**Our Reference:** 860/3298  
**Planning portal Ref:** PP-11551924  
**Date:** 03<sup>rd</sup> October 2022

## **VARIATION OF CONDITION 2 (APPROVED PLANS) OF PLANNING PERMISSION 22/01501/S73**

Edgars have been instructed by the Mr. Harrison, hereinafter known as 'the applicant', in relation to the planning permission 22/01501/S73 relating to Old Rectory Cottage, High Street, Kingham. Planning permission was granted on 13<sup>th</sup> October 2021 for the original application, ref. 21/01189/FUL, which was for:

**Figure 1:** Approved roof plan (left) and proposed roof plan (right)

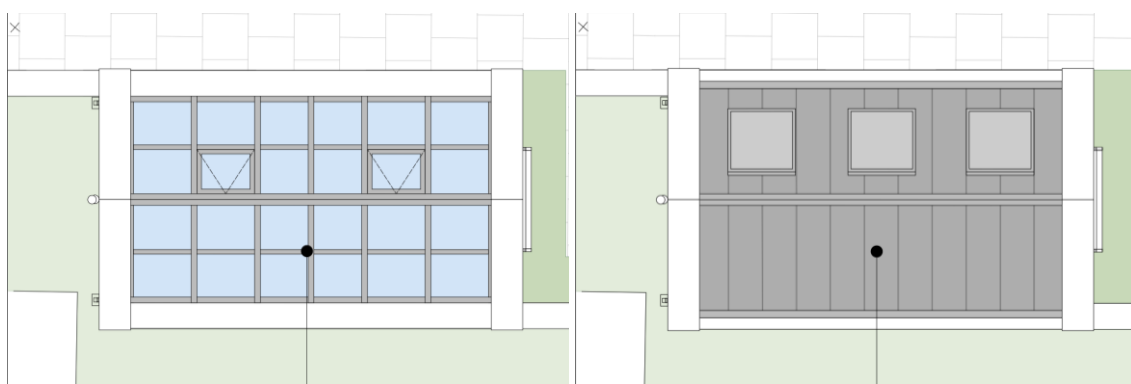
The approved design of the art studio is as a glazed conservatory design. The siting and scale of the proposed art studio is to remain the same but the material palette for the roof of the art studio has been revised after taking into consideration the over-heating to the originally fully glazed conservatory design. Figure 1 below highlights the change in design from the approved plans (left), where it is fully glazed, and the proposed plans (right), where the zinc cladding will be utilized.

**Figure 2:** Approved south-east facing elevation (left) and proposed south-east facing elevation (right)

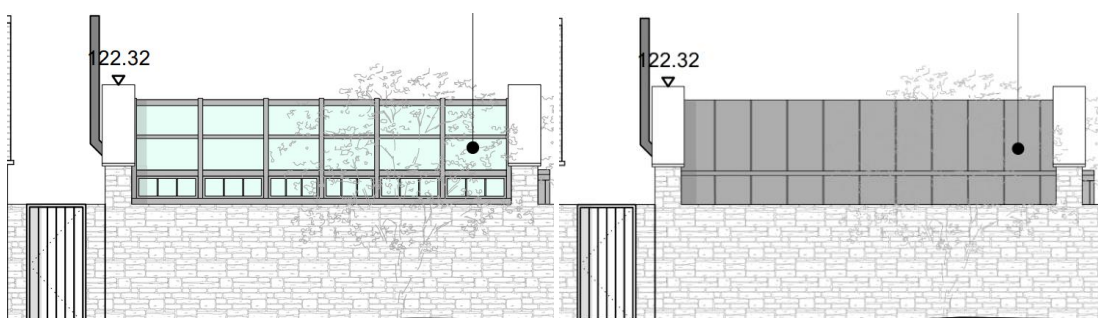
As shown in Figures 2 and 3 below, the south-east facing elevation will display the roof slope clad in zinc and the north-west facing elevation, which will remain glazed as per the approved design, has a revised roof slope clad in zinc with three no. rooflights flush with the roof slope.
